Subject: Pre-Application Summary Notes for Rooted Care Communities (PA2021-0060)

PRE-APPLICATION CONFERENCE MEETING SUMMARY NOTES

Prepared for Rooted Care Communities PA2021-0060

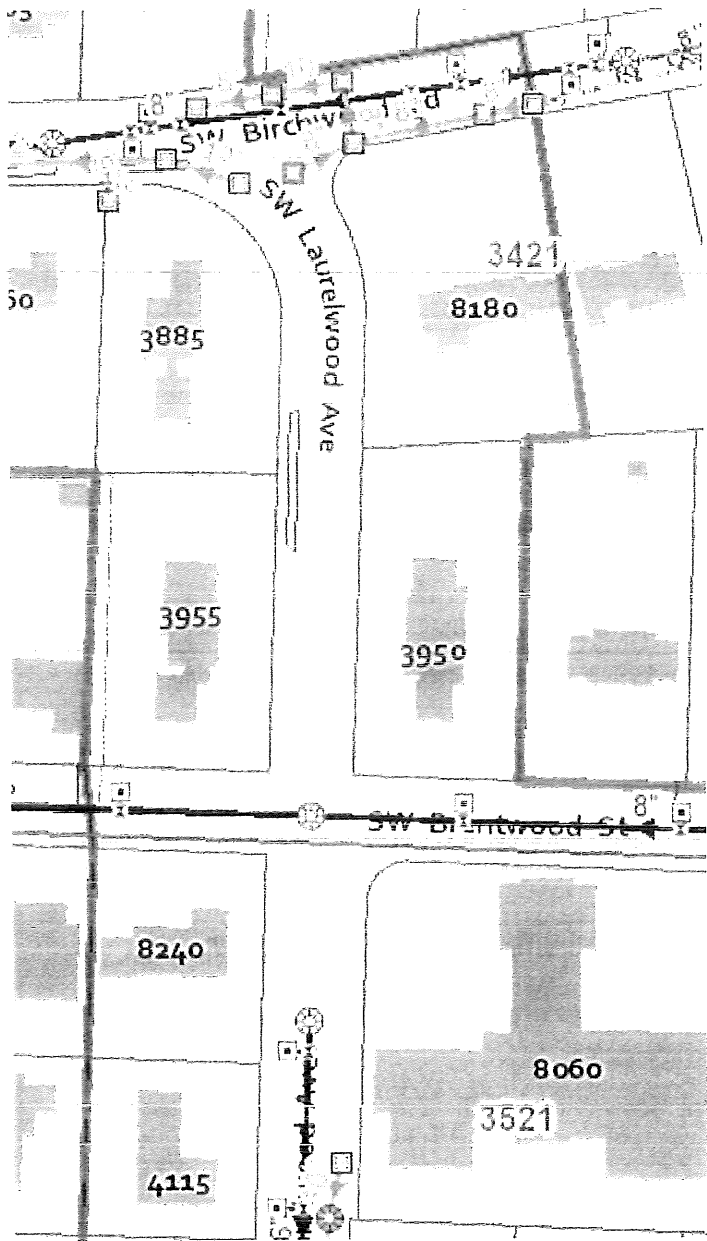
City of Beaverton sanitary sewer is in the vicinity of this project and can serve this site. The property is served by an 8" City of Beaverton sanitary sewer line to the south of the property on SW Brentwood St.

No public storm sewer serves the site currently. Any future tie-ins to storm sewer will require an extension of the public system. Options are City of Beaverton 12" storm sewer on SW Laurelwood Ave approximately 185 feet north of the site, or City of Beaverton 10" storm sewer on SW Laurelwood Ave 245 feet south of the site.
